SERVICE BULLETIN

from: TRIO-KENWOOD COMMUNICATIONS, INC.

SUBJECT: SERVICE NOTES ON TS-820

DATE 10-25-77

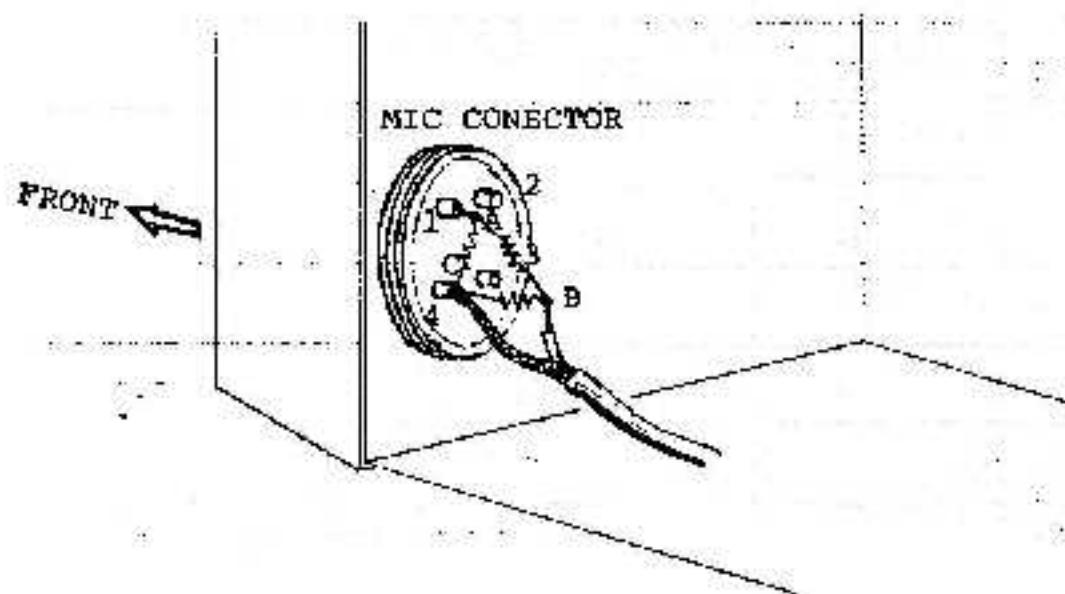
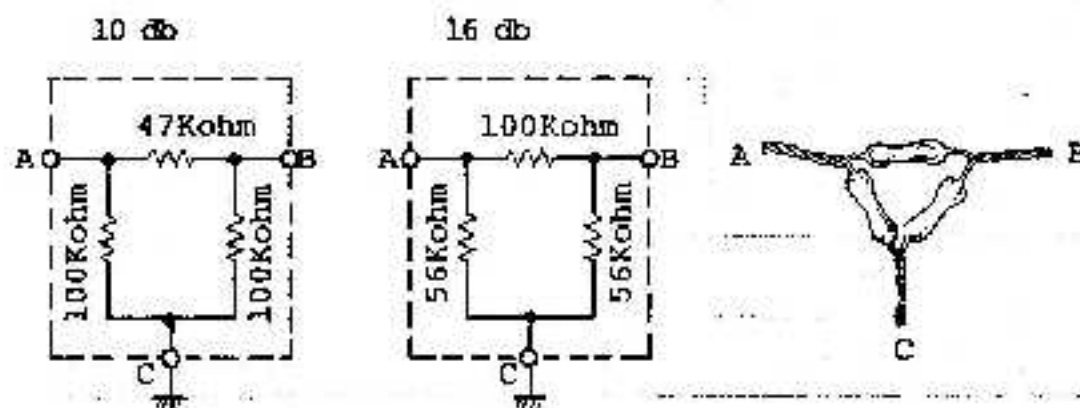
When using a high output microphone (i.e. Shure 444), it is very likely that there will be distortion of the transmitted audio if the processor is used. The reason the distortion occurs is because the processor is between the first microphone amplifier and the microphone gain control. The installation of one of the attenuators shown below will reduce the microphone input to a level that will not cause RF speech processor distortion. The attenuator figures are approximate.

Fig. 1

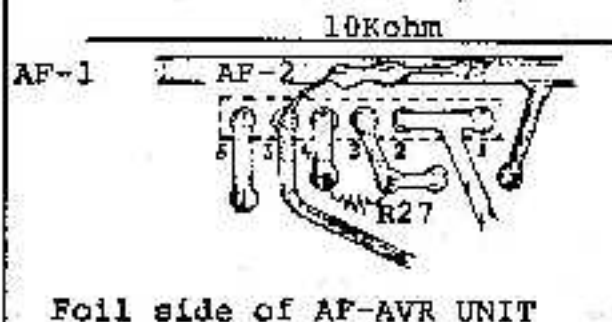
1. Remove resistor R27 (1Kohm) on AF-AVR UNIT (X49-1080-00).
2. Install a 10Kohm resistor on foil side of AF-AVR UNIT --- see Figure 1.
3. Install a 1Kohm resistor on RIT control --- see Figure 2.
4. Install a capacitor (3.3 μ F-10 μ F) between RIT control and ground --- see Figure 2.
5. Adjust VR-2 on AF-AVR UNIT (X49-1080-00) for the same frequency as the center position of the RIT control.
